Staff Report for the Western Weber Planning Commission

Application Request: Consideration and action on a request for preliminary approval of Vaquero Village Cluster Subdivision (13 lots) at approximately 900 South 7100 West.

File Number: LVV 041116

Exhibit B-Review Agencies Comments

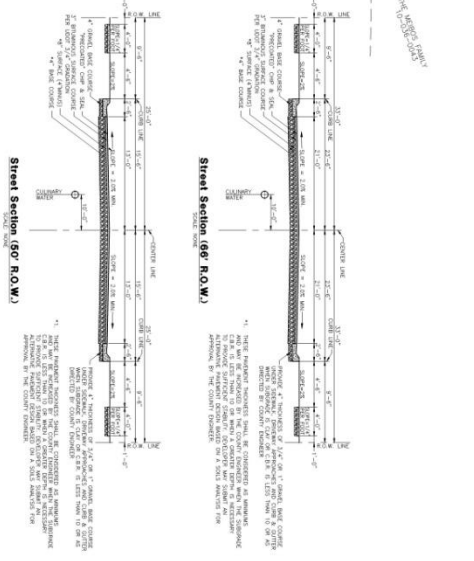
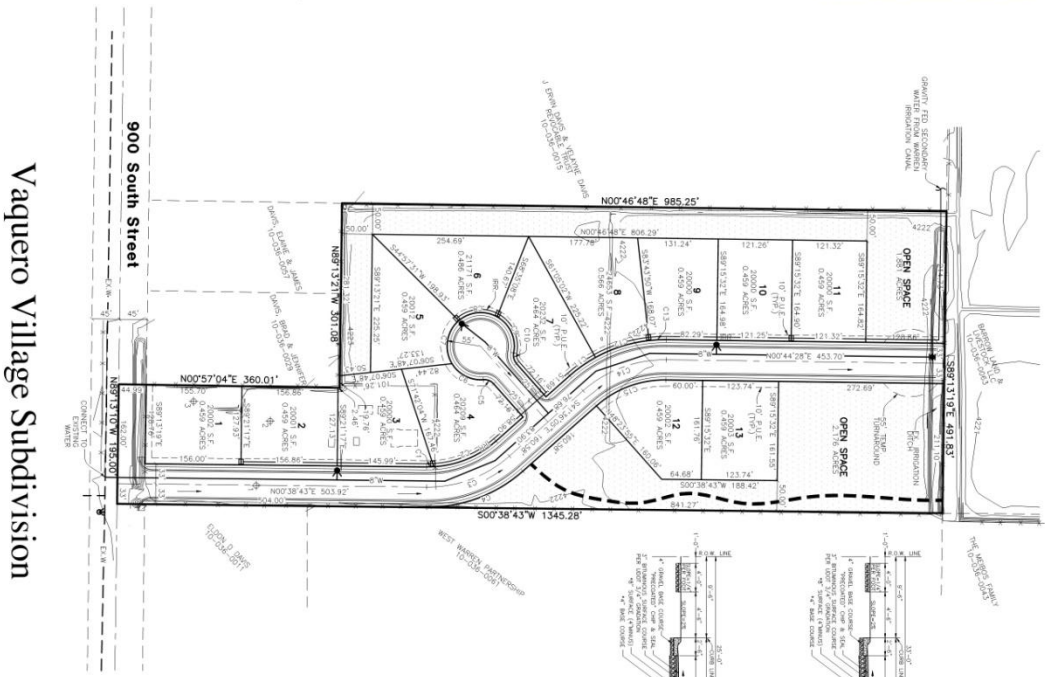
Notes: A formal review of the Vaquero Village Subdivision, 13 lots has been completed by this office. The following items are items of concern which do not meet the verbiage or intent of the Utah Administrative code R3127-4 and/or the Weber-Morgan Health Department Onsite Wastewater Treatment System Regulation.

1) All lots must meet the Weber-Morgan Health Department Onsite Wastewater Treatment System Regulation section 4.39" Minimum lot size shall consist of 20,000 square feet of contiguous buildable area with a slope less than 25 percent." Our office interprets the word "buildable" as area that can be utilized for the construction of structure(s) or onsite wastewater treatment system. Therefore the areas include within restrictive utility easements cannot be considered buildable. All lot must have an area of 20,000 square feet outside of the easements to receive approval from this office

2) This subdivision has been previously included in a much larger future subdivision plan consisting of a total of a 107 half acres lots. The high density development would be required to connect to sanitary sewer as required in the Weber-Morgan Health Department Onsite Wastewater Treatment System Regulation section 4.12" The sewer may be considered as not being available when such sewer is located more than 300 feet from any building which abuts and is served by such sewer. Proposed subdivisions within 300 feet times the number of lots shall be approved only when connected to the public sewer. The rearrangement or subdivision of a parcel into smaller parcels or multiple phase subdivisions shall not be deemed cause to permit the construction of an onsite wastewater treatment system, and all plumbing and drainage systems on any such parcel or parcels shall connect to the public sewer."

The developer must design and record the subdivision in a manor not indicating future phasing. The developer has proposed to terminate the trough road with a cul-de-sac to eliminate the possibility of future phasing. This must be reflected on the final Mylar to receive approval from our office.

3) Lots 1, 2, 3, and 4. At the time of the soil evaluation dated June 16, 2016 a septic system servicing an existing home was encounter in soil evaluation test pit # 4. The area utilized as a septic absorption field cannot again be utilized for that purpose and must be discounted as portion of the 20,000 square foot buildable space required in the Weber-Morgan Health Department Onsite Wastewater Treatment System Regulation, unless a statement is provided by the Weber County Planning department that the area can be utilized as portion of the building pad with all required structural consideration and setbacks being meet. Our office is requiring adequate engineering showing the extent of the existing absorption drain field, the proposed building pad, and an area large enough for both the original and replacement absorption drain field for lots 1, 2, 3 and 4 for consideration of approval.

4) An area located near water table monitoring port 4E has been identified as a location of a preexisting abandoned "Grain Silo" or other holding tank which has been filled in and is no longer in use. The area of excavation cannot be used as portion of the septic absorption field because it has been disturbed and does not meet the Utah Administrative code R317-4-6.14.B.4.c. The area must be discounted as portion of the 20,000 square foot buildable space required in the Weber-Morgan Health Department Onsite Wastewater Treatment System Regulation, unless a statement is provided by the Weber County Planning department that the area can be utilized as portion of the building pad with all required structural consideration and setbacks being meet.
